# Mobile Pentium® II Processor Specification Update

Release Date: January 25, 1999

Order Number: 243887-007

**New Mobile Pentium® II Processor in Mini-Cartridge Package Label with Supplier Matrix Mark Removed**

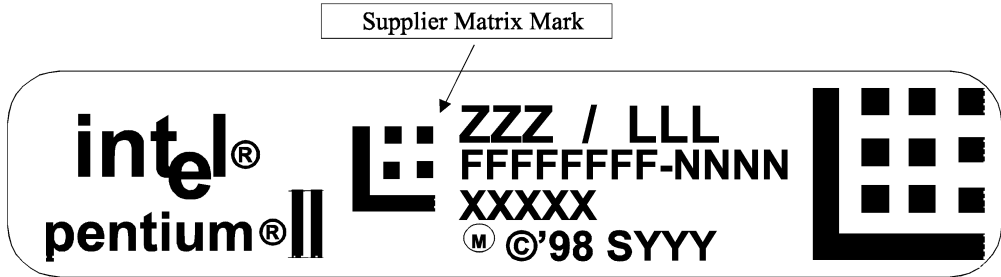
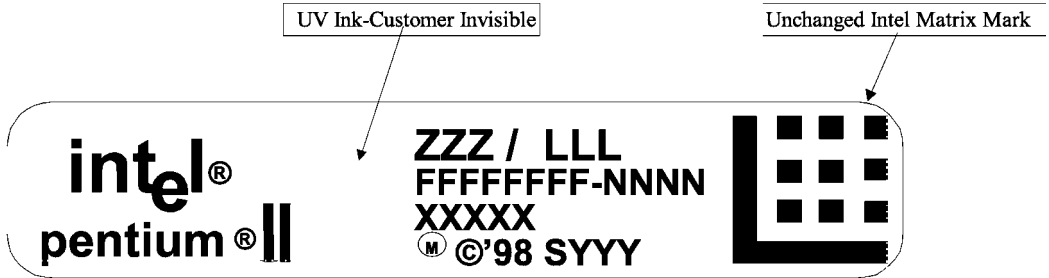
**Current Mobile Pentium® II Processor in Mini-Cartridge Package Label with Supplier Matrix Mark**

Figure 2. Workaround Flowchart: SMBALERT#-Driven System

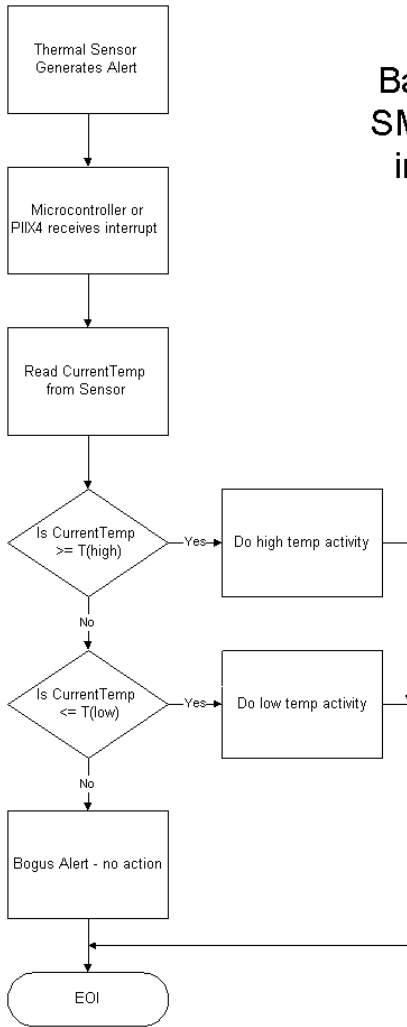
Under the conditions described below, the thermal sensor incorrectly generates the SMBALERT# interrupt. *All* of the following conditions must be met to trigger a false interrupt:

1. Before servicing an interrupt from the thermal sensor, read and compare the processor thermal reading with the threshold limits ( $T_{HIGH}$  or  $T_{LOW}$ ). Figures 2 and 3 provide basic flowcharts for the implementation of this workaround in an interrupt driven system.
2. If the firmware implemented polls the Status Register only, then before taking any action, re-read the temperature register and do a comparison with the alarm threshold limits ( $T_{HIGH}$  or  $T_{LOW}$ ) to determine if the value is actually still within the temperature window.
3. Use a temperature polling scheme to monitor the processor temperature.

Figure 5.6. Cross Sectional View with Vertical Dimensions

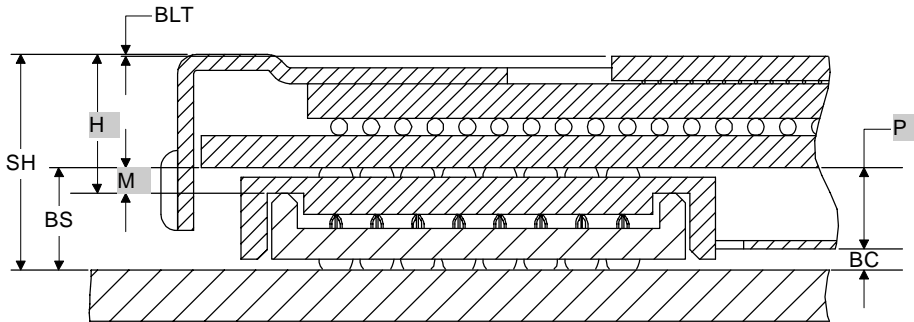
**B12. Misabeled Vertical Dimension Parameters**

Figure 5.6 in the *Mobile Pentium® II Processor at 233 MHz, 266 MHz, and 300 MHz* datasheet should be replaced by the following figure:
